IEEE 802.11
Wireless Access Method and Physical Specification

Title: **FH PHY Proposed Revisions to Section 10**

Date: March 28, 1995

Abstract: This paper presents the changes to section 10 in the Draft Standard P802.11/D1 as a result of the Response to Draft D1 Letter Ballot processed at the March 1995 Meeting as shown in the companion document P802.11-95/77

Figure 10-3: PLCP Frame Format

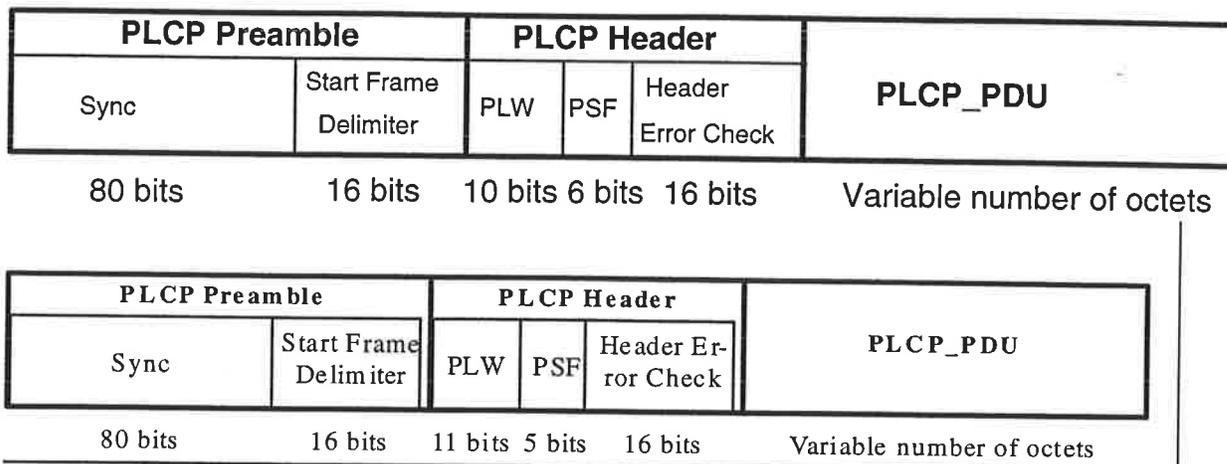
The PLCP Frame Format provides for the asynchronous transfer of MAC Layer MPDU from any transmitting ~~station~~node to all receiving ~~stations~~nodes within the wireless LAN. The PLCP frame format illustrated in Figure 10-3 consists of three parts: a PLCP Preamble, a PLCP Header, and a PLCP_PDU. The PLCP Preamble provides a period of time for several receiver functions. These functions include antenna diversity, clock and data recovery and ~~data~~field delineation of the PLCP Header and the PLCP_PDU. The PLCP Header is used to specify the length of the MPDU field and support any PLCP management information. The PLCP_PDU contains the MPDU data modified by the ~~MPDU~~PLCP_PDU data whitener.

Figure 10-7: Transmit State Machine

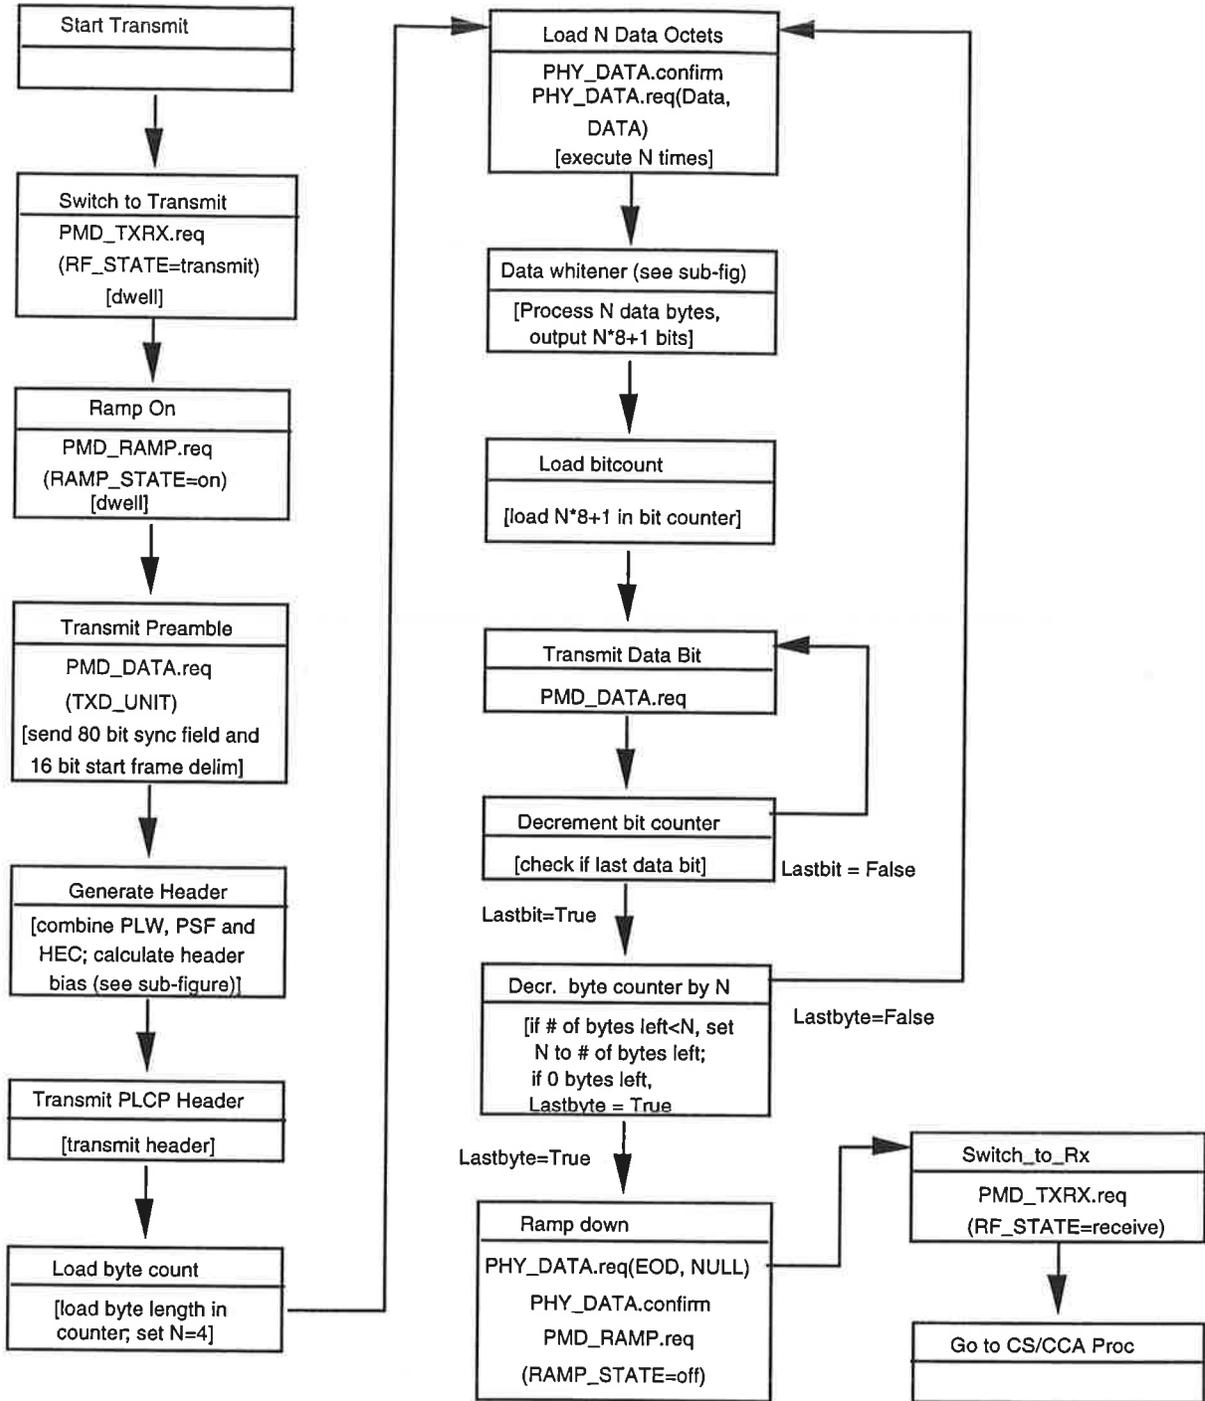
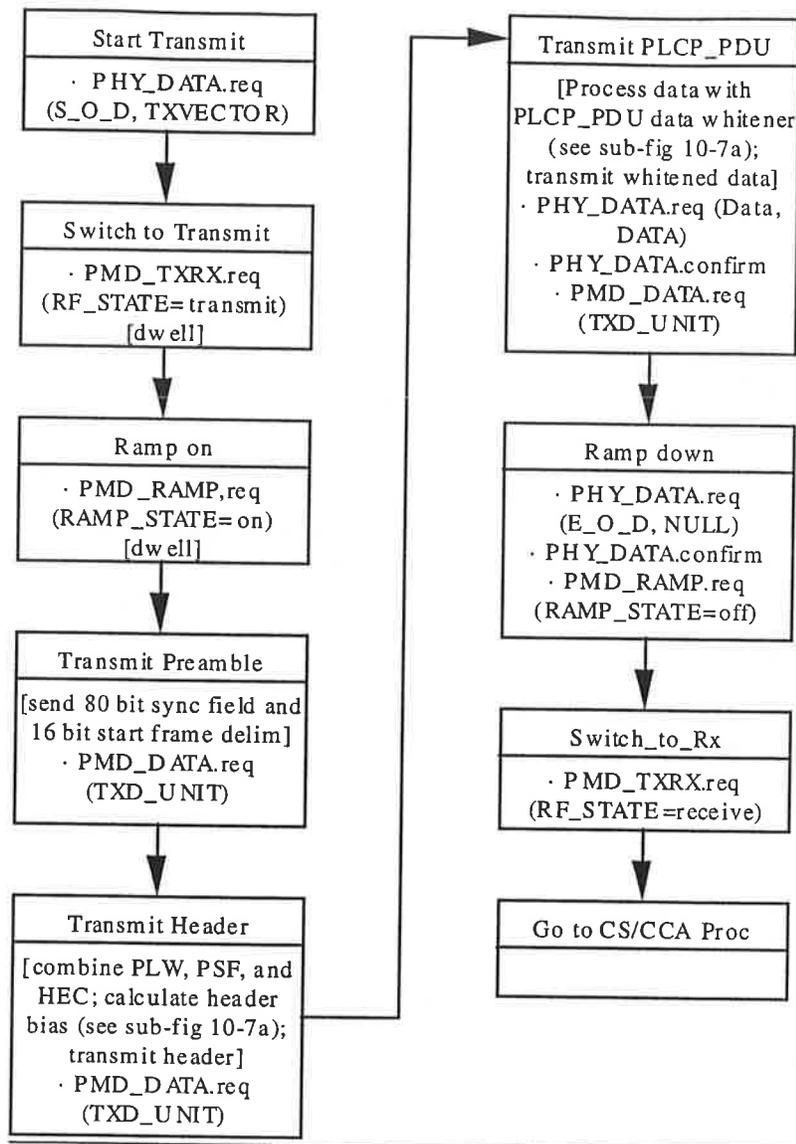
The PLCP transmit state machine illustrated in Figure 10-7 includes functions that must be performed prior to, during, and after MPDU data transmission. Upon entering the transmit procedure in response to a *PHY_DATA.request(Start_of_Data, TXVECTOR)* from the MAC, the PLCP shall switch the PHY PMD circuitry from receive to transmit state; ramp on the transmit power amplifier in the manner prescribed in Section 10.6 (PMD specification); and transmit the preamble sync pattern and start frame delimiter. The PLCP shall generate the PLCP header as defined in Section 10.3.2.2 (PLCP Header) in sufficient time to send the bits at their designated bit slot time. The PLCP shall add the PLCP header to the start of the PLCP_PDU data.

Prior to transmitting the first MPDU data bit, the PLCP shall send a *PHY_DATA.confirm* message to the MAC indicating that the PLCP is ready to receive an MPDU data octet. The MAC will respond by sending a *PHY_DATA.request(Data, DATA)*. This sequence of *PHY_DATA.confirm* and *PHY_DATA.request(Data, DATA)* shall be executed whenever the PLCP is ready for more data and until the last data octet is passed to the PLCP. During transmission of the PLCP_PDU data, each bit of the MPDU passed down from the MAC shall be processed by the data whitener algorithm defined in Figure 10-7a and described in section 10.3.2.3 (PLCP_PDU Data Whitener). The MPDU data bytes are processed and transmitted LSB first and MSB last.

Figure 10-9: CS/CCA State Machine.

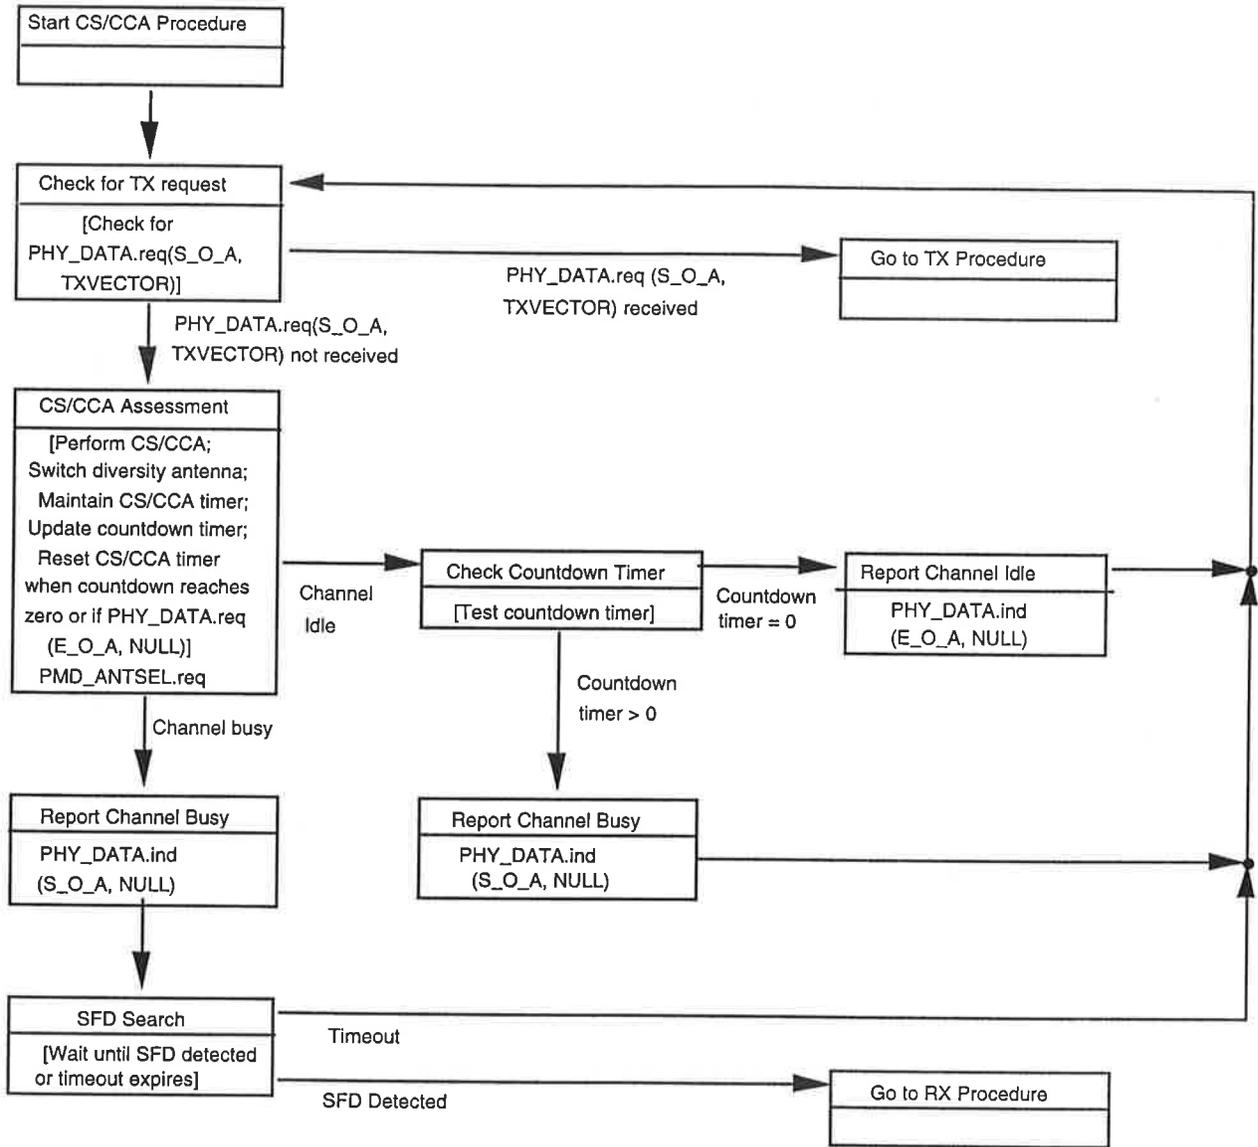
If a CS/CCA assessment returns a channel busy result, the PHY shall send a *PHY_DATA.indicate(Start_of_Activity, NULL)* to the MAC. Upon a channel busy assessment, the PLCP shall stop any antenna switching prior to the earliest possible arrival time of the start frame delimiter (SFD) and detect a valid SFD if received. If a valid SFD is detected, the CS/CCA procedure shall exit to the receive procedure. The PLCP shall dwell and search for the SFD for a minimum period longer than the latest arrival time of the SFD. Indication of a busy channel does not necessarily lead to the successful reception of a framepacket.

Upon exiting the CS/CCA procedure to receive a framepacket, the last indication of CS/CCA was BUSY. The indication remains BUSY when returning from the receive procedure until the first CS/CCA assessment is performed and determines that the channel is IDLE. ~~If the MAC is sending an ACK following a valid received packet, the MAC should ignore the CS/CCA busy indication immediately following the end of the received packet.~~

The countdown timer may be a non-zero value when returning from the receive procedure if a signal in the process of being received was lost prior to the end as positively indicated in the length field of a valid PLCP header. The countdown timer shall be used to force the CS/CCA indication to remain in the BUSY state until the predicted end of the framepacket regardless of actual CS/CCA indications. However, if the CS/CCA procedure indicates the start of a new framepacket within the countdown timer period, it is possible to transition to the receive procedure prior to the end of the countdown timer period. When a non-

Figure 10-11: Receive State Machine

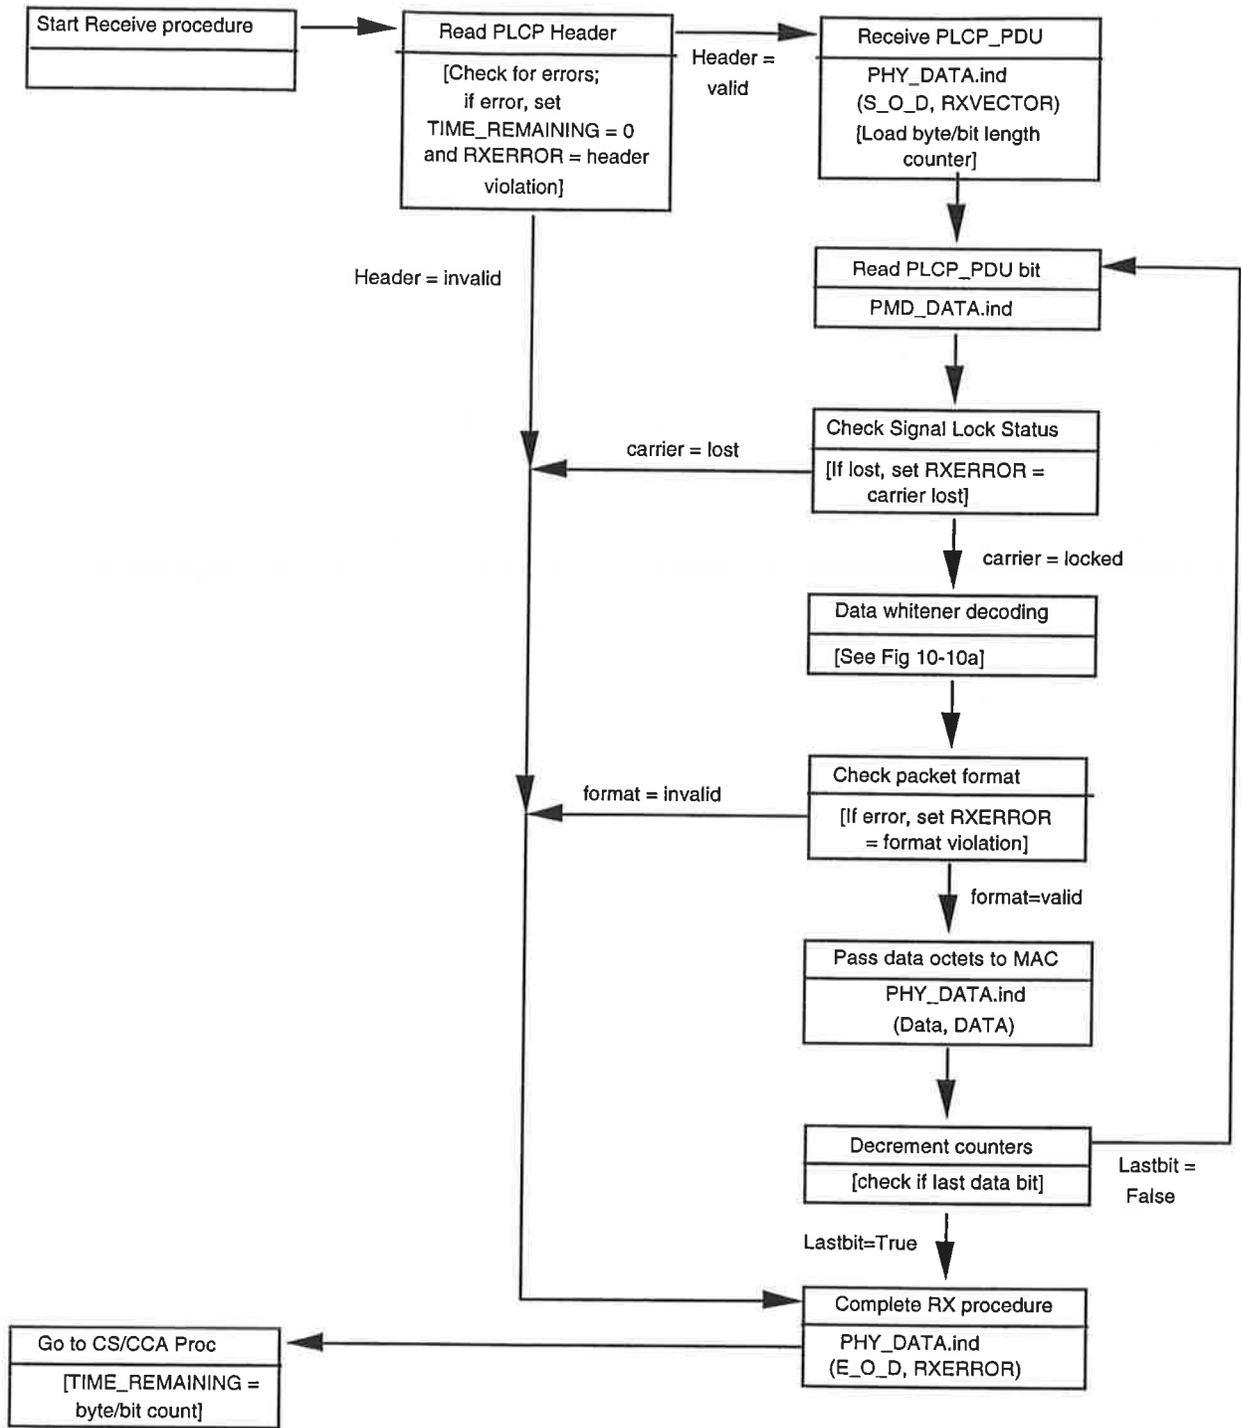
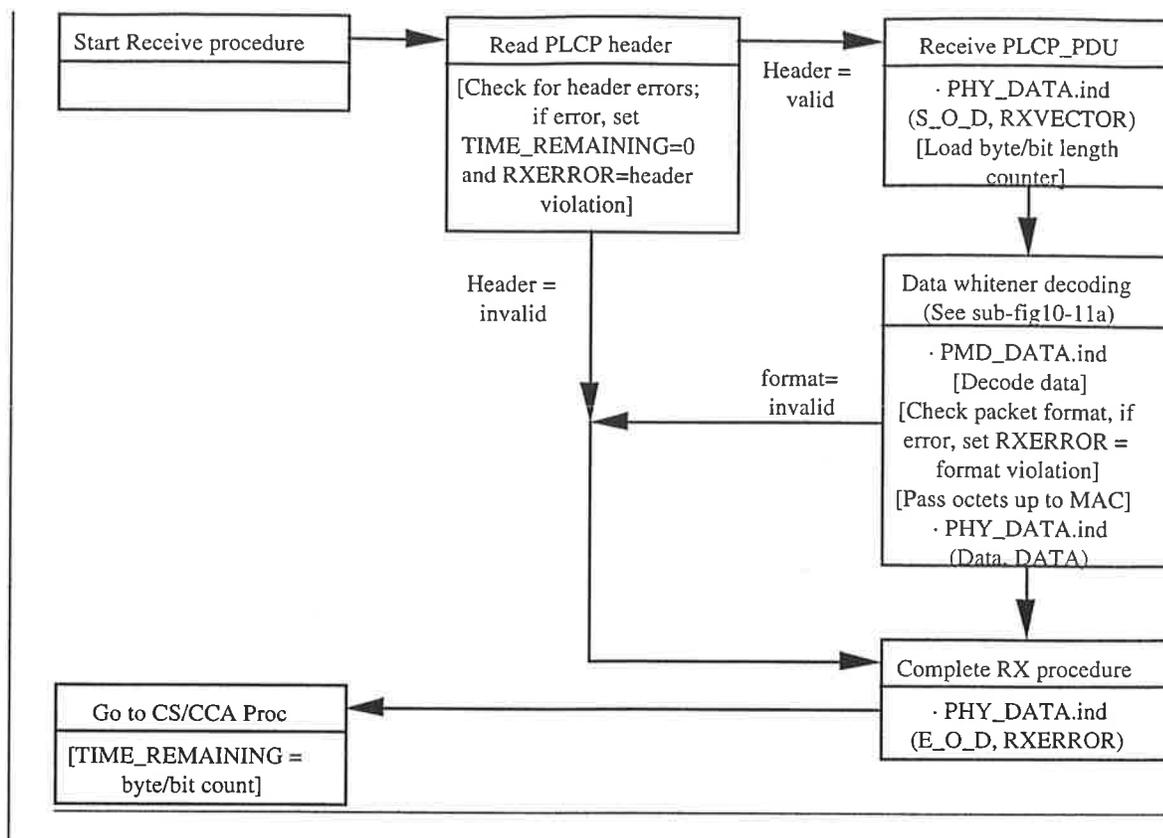
If the PLCP header contains ~~uncorrectable-any bit~~ errors, the PLCP shall immediately set the byte/bit counter to zero, complete the receive procedure with a *PHY_DATA.indicate(End_of_Data, RXERROR=header violation)* to the MAC, and return to the CS/CCA procedure with *TIME_REMAINING=0*. ~~If after receiving a valid PLCP header, the signal is interrupted for any reason, the PLCP shall immediately complete the receive procedure with a *PHY_DATA.indicate(End_of_Data, RXERROR=carrier lost)* to the MAC, and return to the CS/CCA procedure with *TIME_REMAINING=byte/bit count remaining*.~~ If any format error was detected during the reception of the packet, the PLCP shall immediately complete the receive procedure with a *PHY_DATA.indicate(End_of_DATA, RXERROR=format violation)* to the MAC, and return to the CS/CCA procedure with *TIME_REMAINING=byte/bit count remaining*.

Figure 10-12: Receive Timing

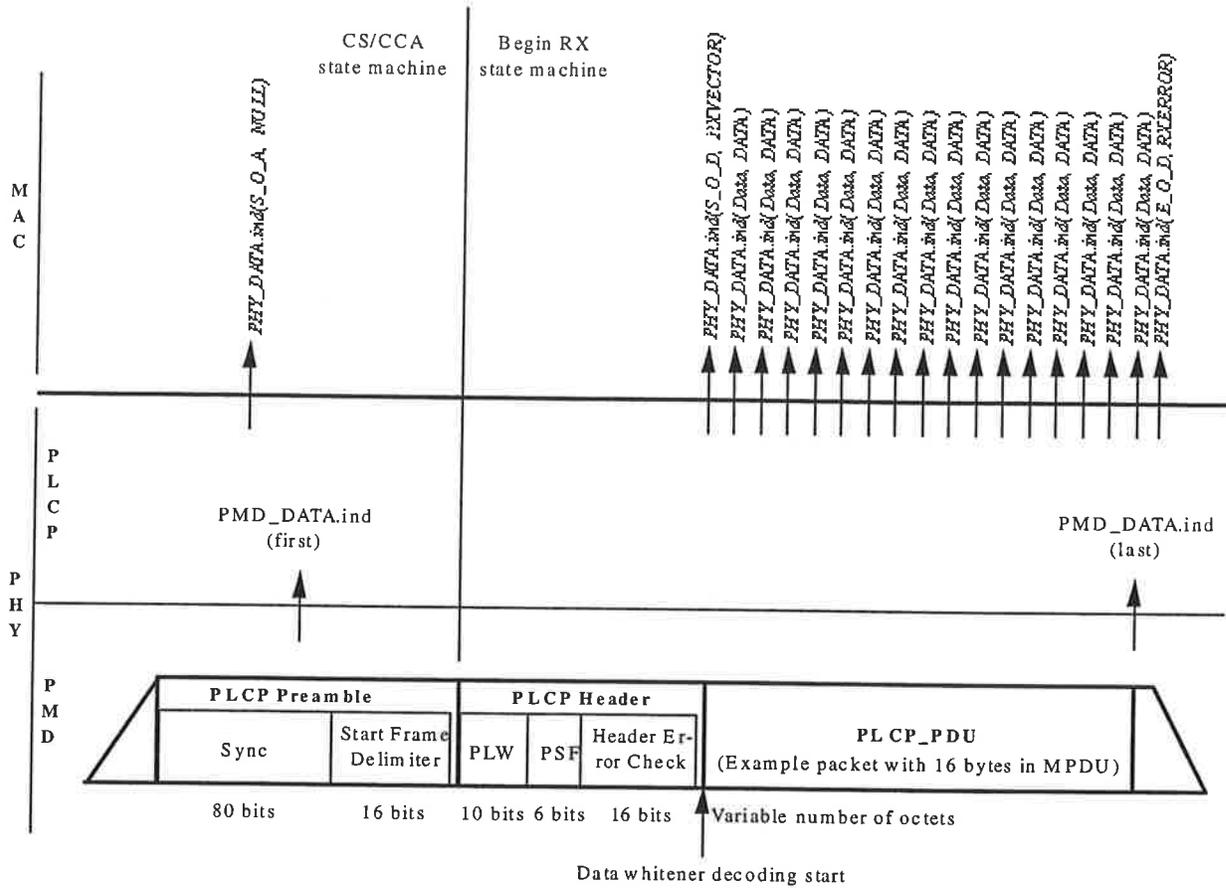
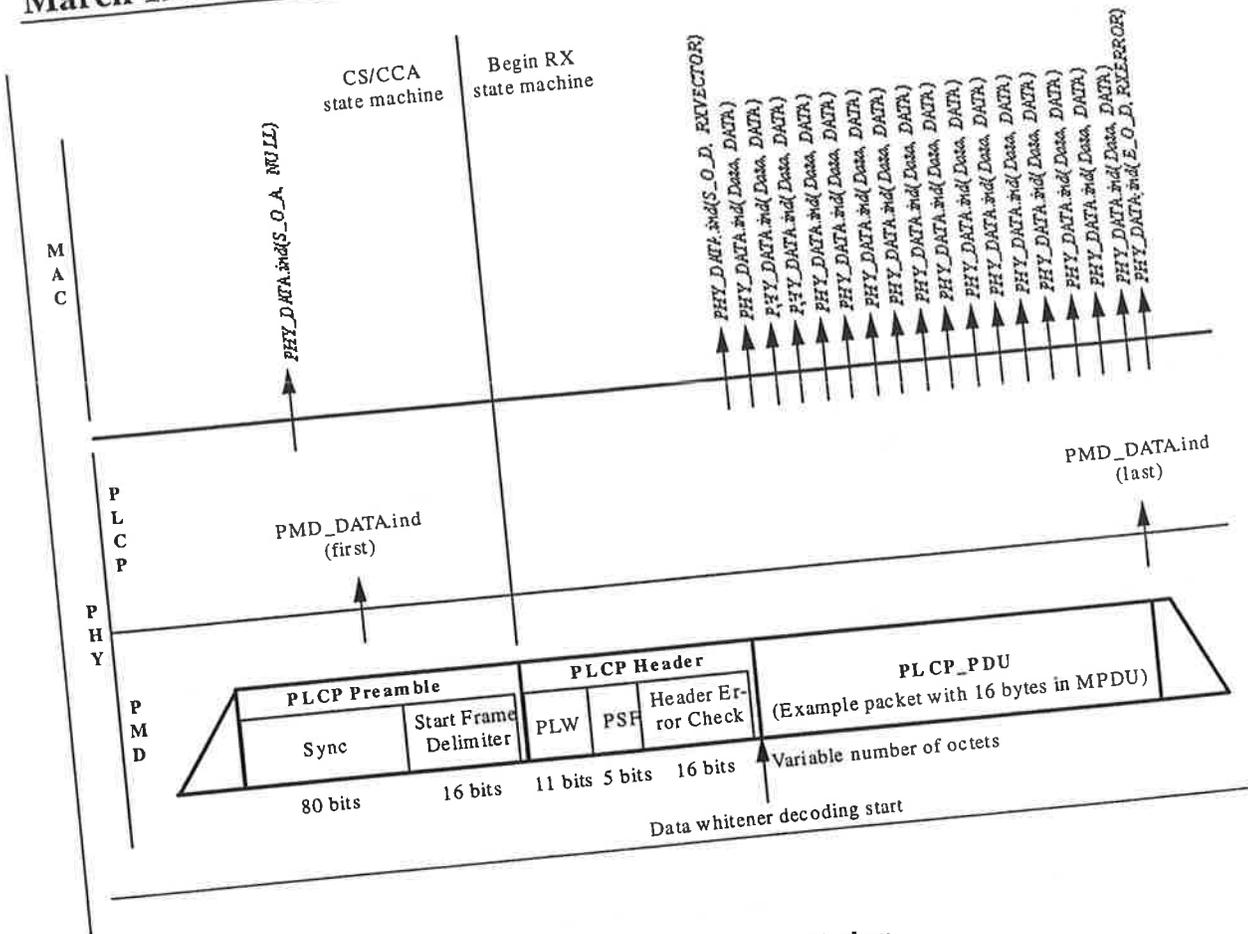
If there was an ~~uncorrectable~~ error in the PLCP header, the PLCP shall terminate the receive procedure within 8 μ s of the end of the PLCP header. If any other error was detected during the reception of the packet, the PLCP shall terminate the receive procedure within 8 μ s of detecting the error.
